BEFORE THE MINNESOTA PUBLIC UTILITIES COMMISSION

In the Matter of the Application of Minnesota Power, Great River Energy, and Otter Tail Power Company for a Certificate of Need for the Maple River – Cuyuna 345kV Transmission Line Project. DOCKET No. ET-3,E-002/CN-25-109

**COMMENT OF
DONNA J. ANDERSEN AND CURTIS ANDERSEN, AND DONNA’S ACRES, LLC**

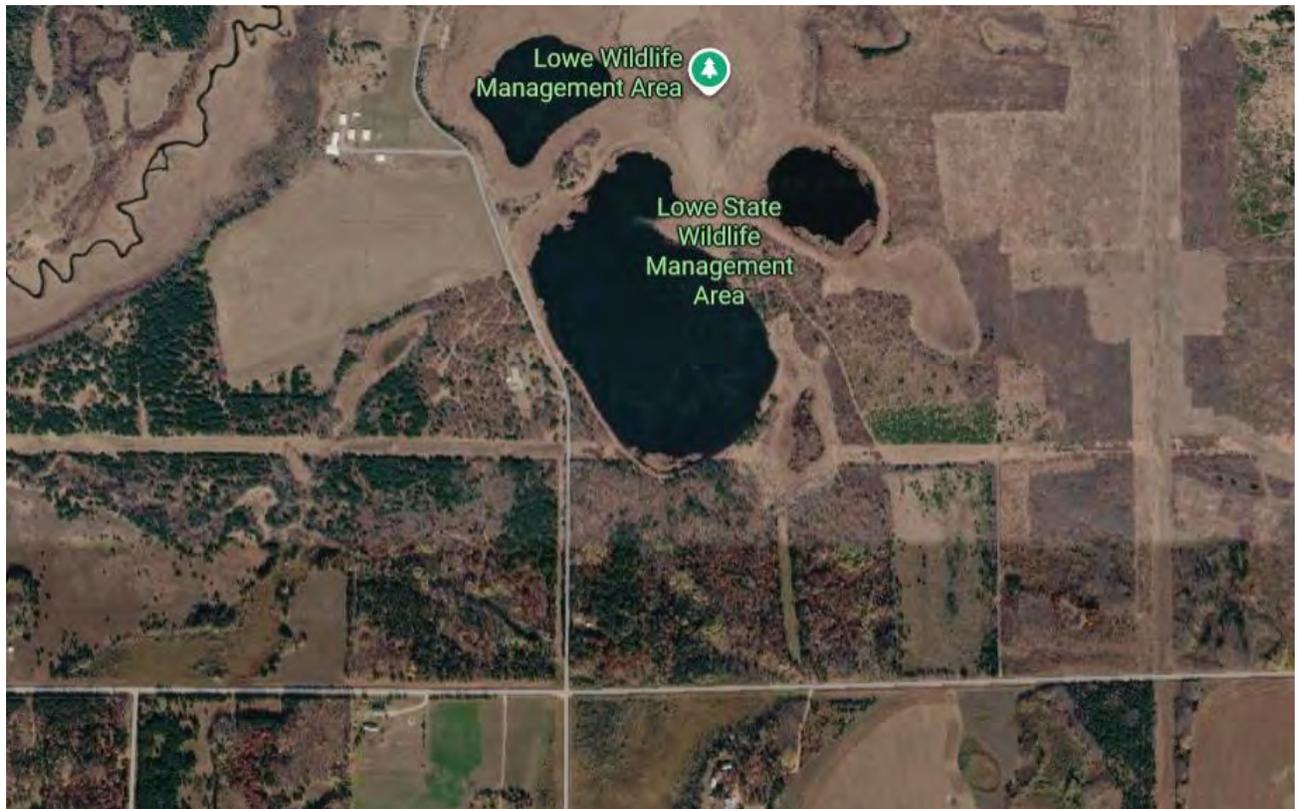
Andersen’s property is on the route proposed in a narrow pinch point surrounded on the east and south sides by roads and the north and south sides by transmission and to the east, a

A map clearly focused on the Andersen property showing the forest, the WMA, the two transmission lines at the north and south of the Andersen property, and the pipeline to the east must be entered in the record – the maps in the application have insufficient detail.

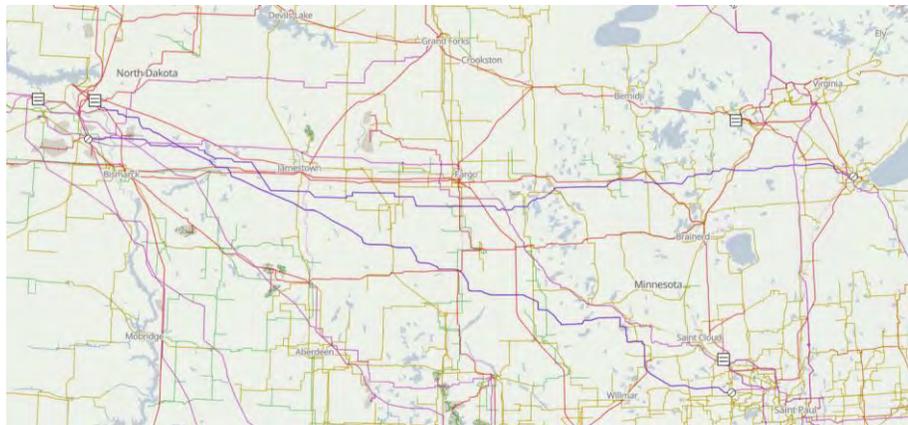
On Appendix D, page 16 of 20, there's a poor depiction of infrastructure at the Andersen parcel on Hubbard County Road, in the most southwest corner of Hubbard County, at the northeast corner of the intersection of Hubbard County, Wadena and Becker Counties.

A logical system alternative would be to underbuild the existing line south of County Line Road in the potato field on the 345kV line.
